ENCLOSURE 5

SHEARON HARRIS NUCLEAR POWER PLANT
NRC DOCKET NO. 50-400/LICENSE NO. NPF-63
REQUEST FOR LICENSE AMENDMENT
REACTOR COOLANT SYSTEM (RCS) FLOW RATE

TECHNICAL SPECIFICATION PAGES

FIGURE.2.1-1
 REACTOR CORE SAFETY LIMITS - THREE LOOPS IN OPERATION
 WITH MEASURED RCS FLOW $\geq [293,540 \text{ GPM} \times (1.0 + C_1)]$

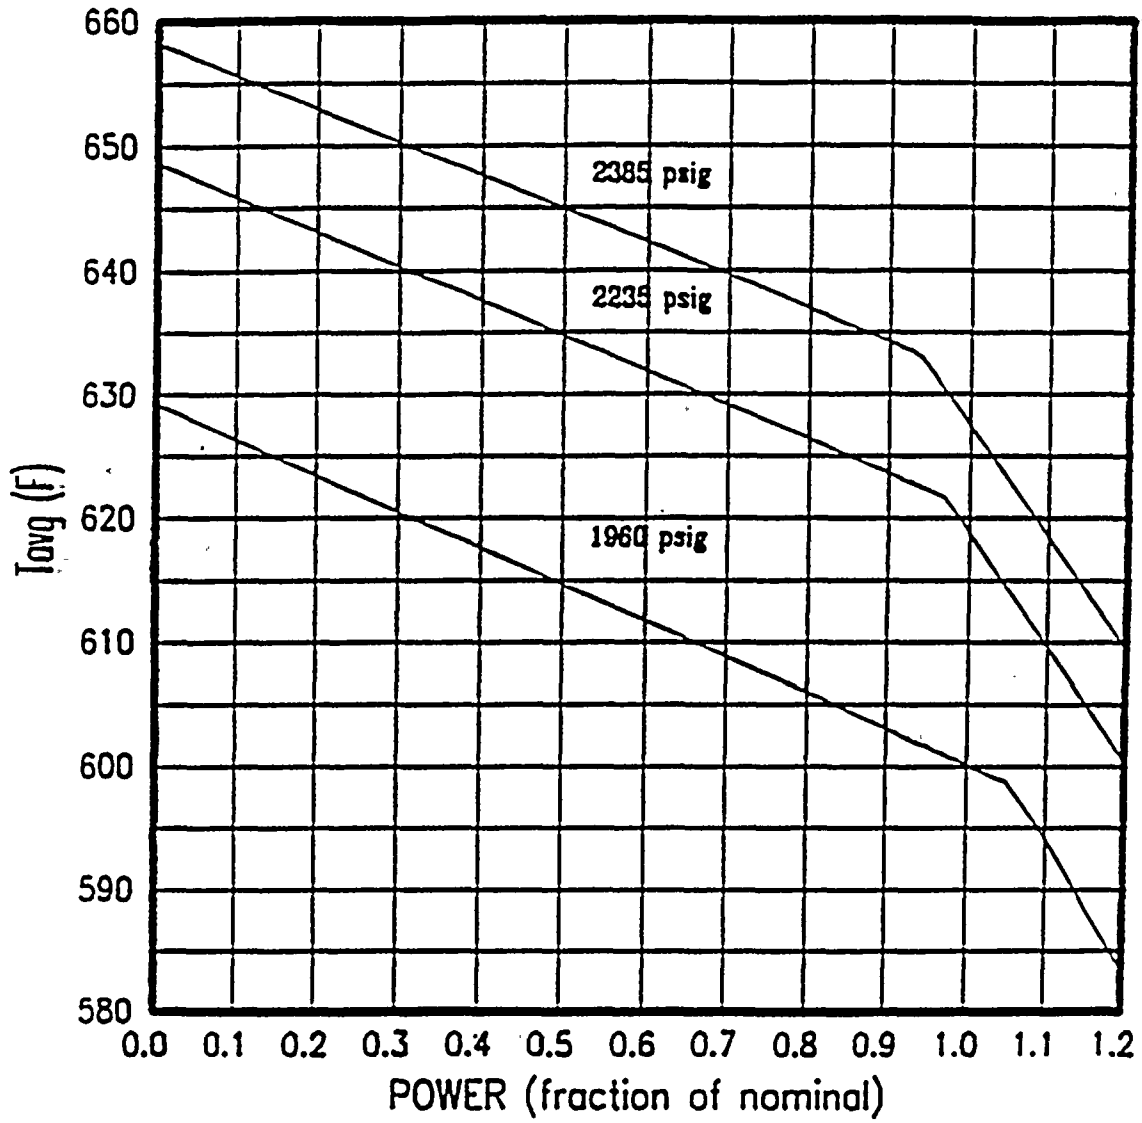
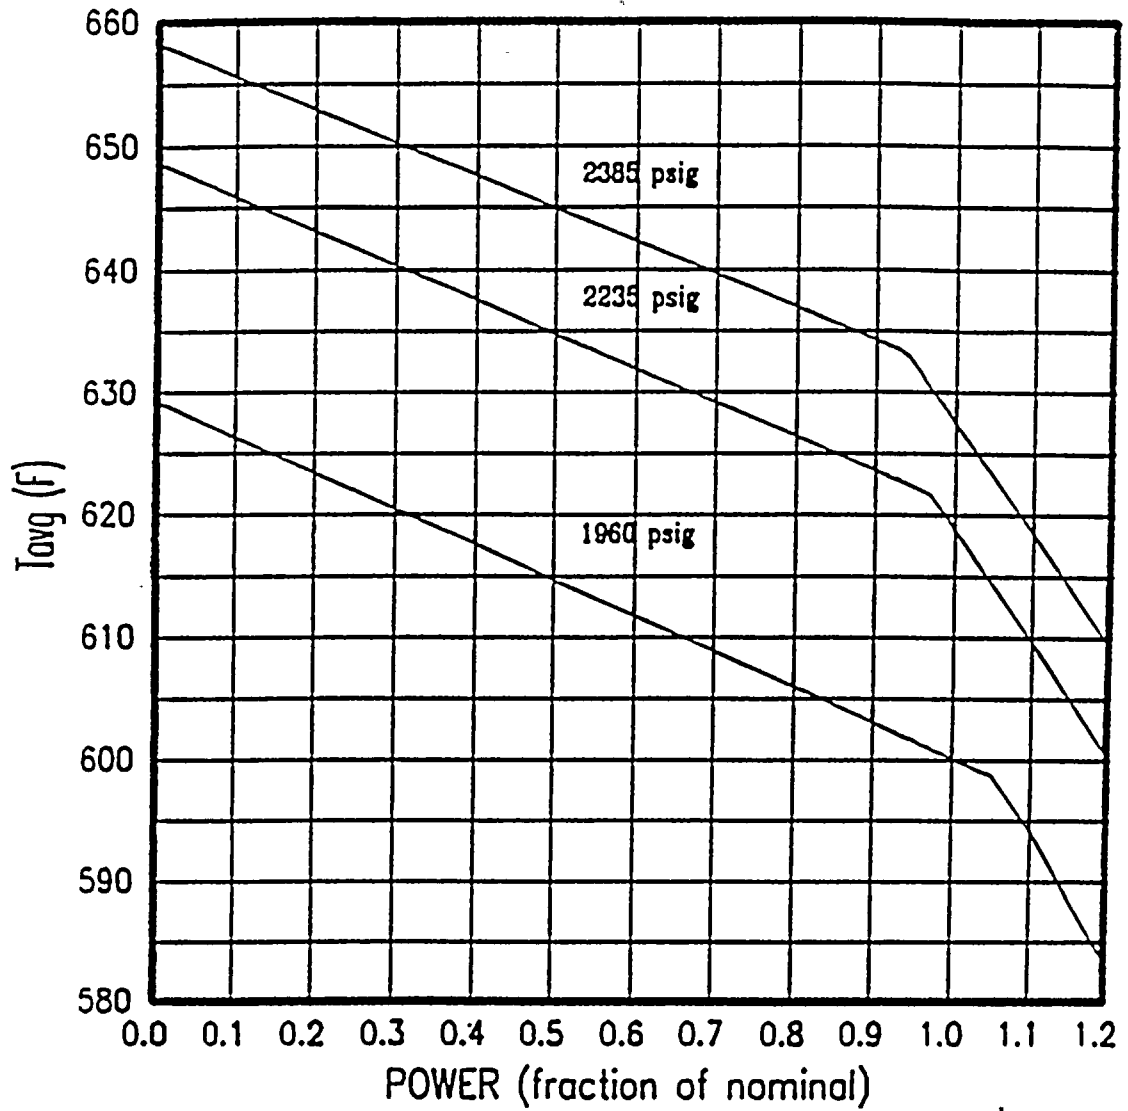
NOTE 7: This value is associated with measured RCS flow $\geq [293,540 \text{ gpm} \times (1.0 + C_1)]$. Technical Specification 3/4.2.3 requires this setpoint to be reduced at the rate of 1.5% of RTP for each 1% that measured RCS flow is below $[293,540 \text{ gpm} \times (1.0 + C_1)]$.

Figure 3.2-3

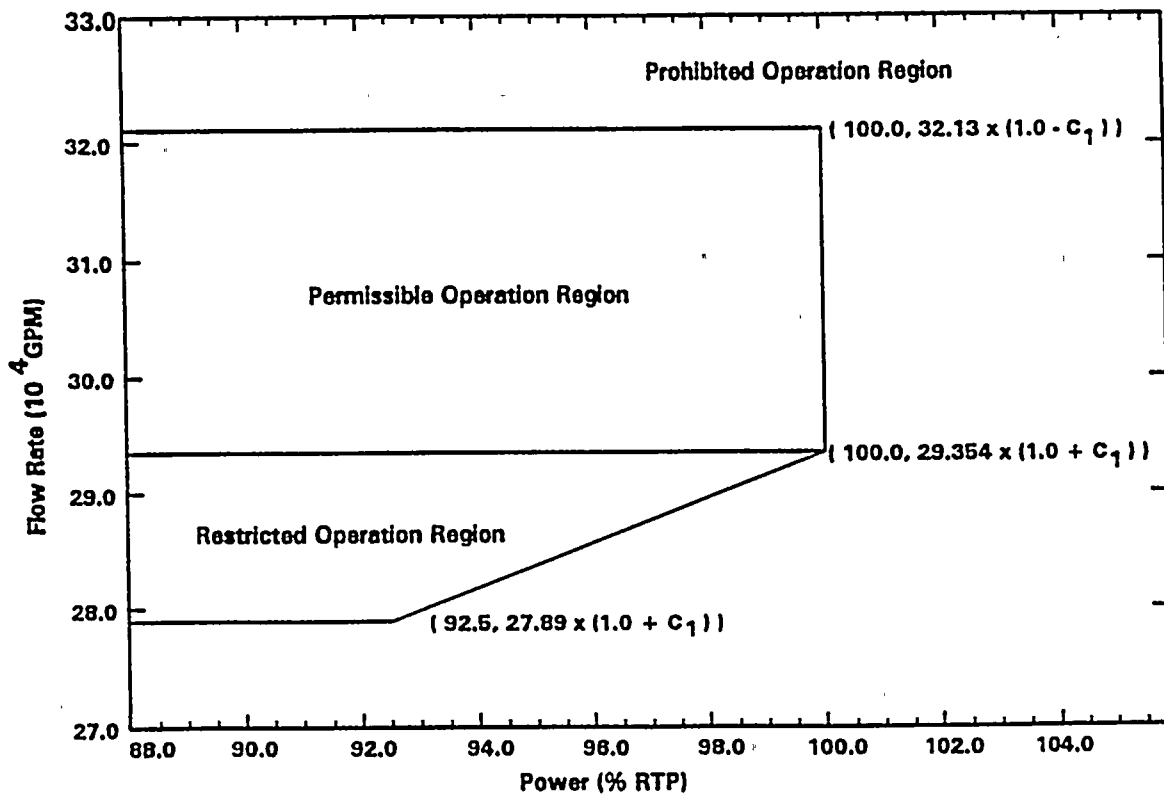
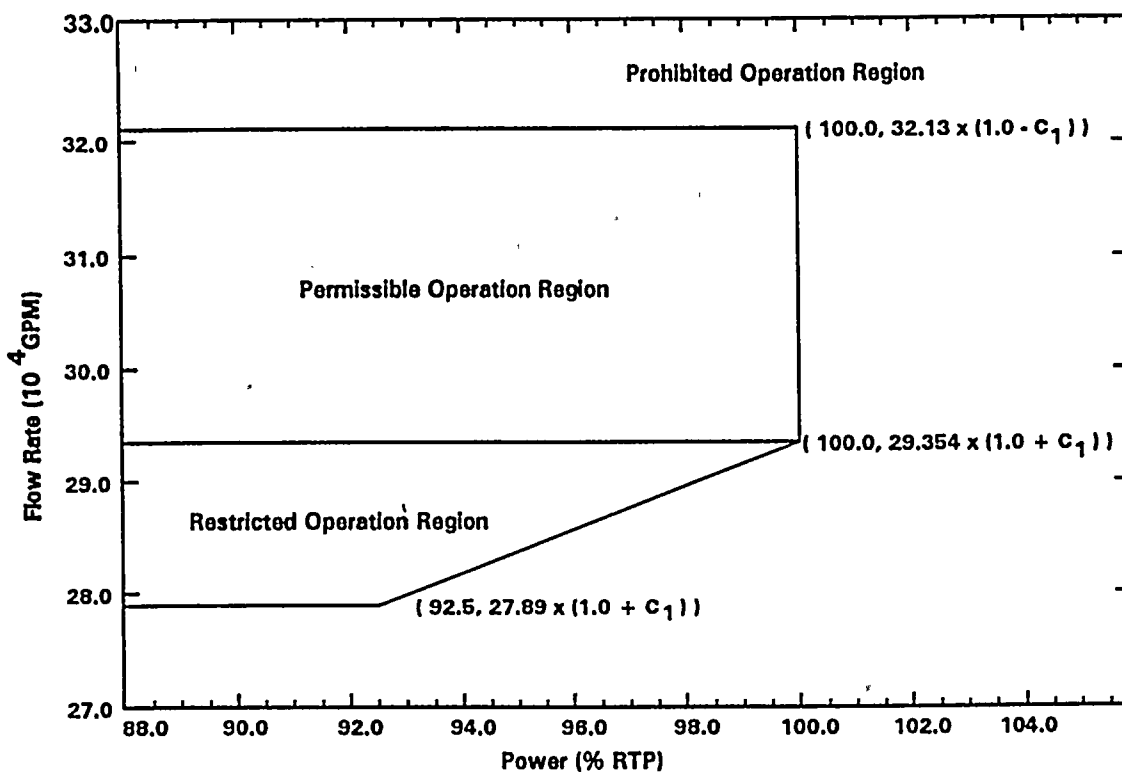
3.2.3 The combination of indicated Reactor Coolant System (RCS) total flow rate and THERMAL POWER shall be maintained within the region of permissible operation shown on Figure 3.2-3 for three loop operation and $F_{\Delta H}$ shall be maintained as follows:

a. With the combination of RCS total flow rate and THERMAL POWER within the region of prohibited operation shown on Figure 3.2-3 or $F_{\Delta H}$ outside the limits given in 3.2.3a.:

- b. With the combination of RCS total flow rate and THERMAL POWER within the region of restricted operation (flow rate less than $[293,540 \text{ gpm} \times (1.0 + C_1)]$, which includes measurement uncertainty for core flow, C_1 , as described in the Bases), within 6 hours reduce the Power Range Neutron Flux-High Trip Setpoint to below the nominal setpoint by the same amount (% RTP) as the power reduction required by Figure 3.2-3 and maintain $F_{\Delta H}$ at a value that is less than or equal to the value of $F_{\Delta H}$ at RATED THERMAL POWER.

- c. Within 24 hours of initially being within the region of prohibited operation shown on Figure 3.2-3 either:
 1. Verify through RCS total flow rate determination and incore flux mapping that the combination of RCS total flow rate and THERMAL POWER are restored to within the region of permissible operation, and $F_{\Delta H}$ to within the limits given in 3.2.3a., or

$F_{\Delta H}$ will be maintained within its limits provided Conditions a. through d. above are maintained. The combination of measured RCS flow rate and THERMAL POWER must be maintained within the regions of permissible or restricted operation as shown in Figure 3.2-3 to ensure that the combination of RCS flow rate and THERMAL POWER are within the ranges considered in the mechanical and safety analyses and, along with the measurement of $F_{\Delta H}$, to ensure that the calculated DNBR will not be below the design DNBR value. The relaxation of $F_{\Delta H}$ as a function of THERMAL POWER when in the region of permissible operation allows changes in the radial power shape for all permissible rod insertion limits.

For the FSAR Chapter 15 analyses reliant on the Power Range Neutron Flux - High Trip Setting trip function, reduction of the Setpoint by the same percentage as the required power reduction in Figure 3.2-3 (1.5% RTP per 1% RCS flow rate) ensures DNBR margin is maintained. When in the region of restricted operation, defining ΔT_0 as the equivalent ΔT at 100% RTP and $[293,540 \text{ gpm} \times (1.0 + C_1)]$ (which includes measurement uncertainty for core flow) results in an effective $OT\Delta T$ setpoint reduction and maintains DNBR margins for those analyses reliant upon the $OT\Delta T$ trip. The additional restrictions on $F_{\Delta H}$ when in the region of restricted operation ensure that the margins gained by the power and setpoint reductions are not reduced by the normally allowable increases in radial peaking at reduced power levels.

The upper limit on measured RCS flow rate in Figure 3.2-3
[321,300 gpm x (1.0 - C₁)] protects the mechanical design flow of 321,300 gpm per
FSAR Table 5.1.0-1.
